ICHD - ENVIRONMENTAL HEALTH DIVISION

Statesville Office (704) 878-5305 | Mooresville Office (704) 660-3625 | PERMIT # AP 2022-6159 | BLDR-2023-21219

SEPTIC: IMPROVEMENT PERMIT / AUTHORIZATION TO CONSTRUCT / OPERATION PERMIT / EXISTING SYSTEM

SITE ADDRESS: 117 Riverton Dr, Statesville 28625 | PHONE: 704-277-5688 | ALT. PHONE 704-968-8289

INITIAL SITE SKETCH

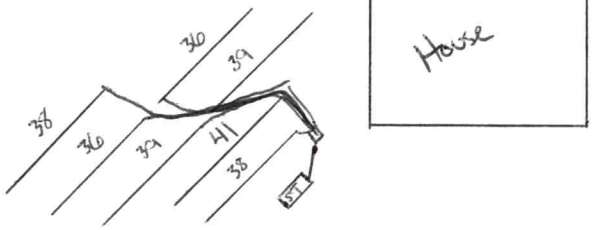
Comments / Conditions: Install lines on contour with the land. Do not grade, park, or drive on septic area. Keep at least 2' of seperation between lines

* Fill Gully *

* Must move fill off of repair before OP *

Proposed alterations to 117 Riverton Dr.
House box.

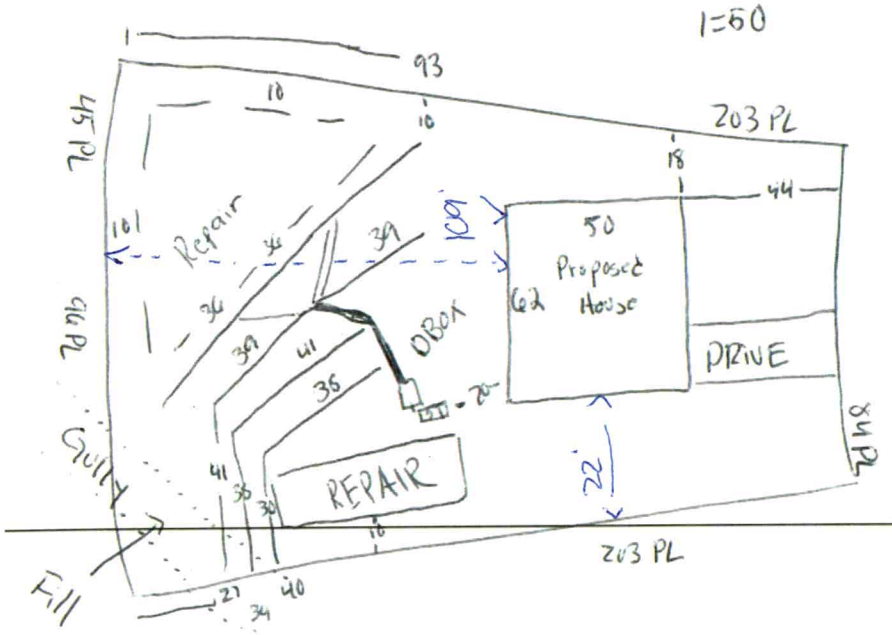
Note	Created By	Date and Time Created
1. ******NOT MEETING 15FT SIDE SETBACK PER PLANS	Julia Bailey	10/10/2022 12:02
2. moving forward revised plans given	Julia Bailey	10/12/2022 8:16

- Moved the house forward to the st. 10 feet.
- expanded the house box width by 6 feet on each side
-
